VALIDATION REPORT

Sindicatum Carbon Capital Limited

**Bangkok Kamphaeng Saen East:
Landfill Gas to Electricity Project**

SGS Climate Change Programme

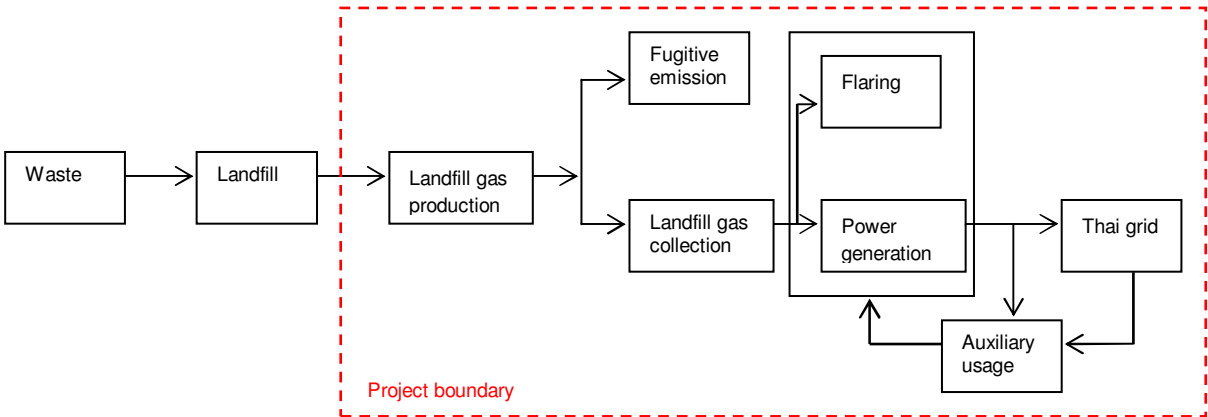
Date:	28/04/2009	Raised by:	Ashok Kumar Gautam		
Type:	CL	Number:	08	Reference:	B.3.3
Lead Assessor Comment:			Date: 28/04/2009		
Project boundary & Identification of the Baseline Scenario

a) The project boundary is not clear for depicted auxiliary usage and the direction of flow from Grid is not clear. Please provide an appropriate diagram for project activity b) Please substantiate that waste would have been dumped at the same site to rule transportation emissions out c) Please substantiate that there are no regulations or policies governing the release of LFG into the atmosphere as written in Sub-step 1b d) Please substantiate that feeding power from LFG to Grid is as per law and necessary documentary evidence for the designated electricity generation capacity.					
Project Participant Response:			Date: 18/05/2009
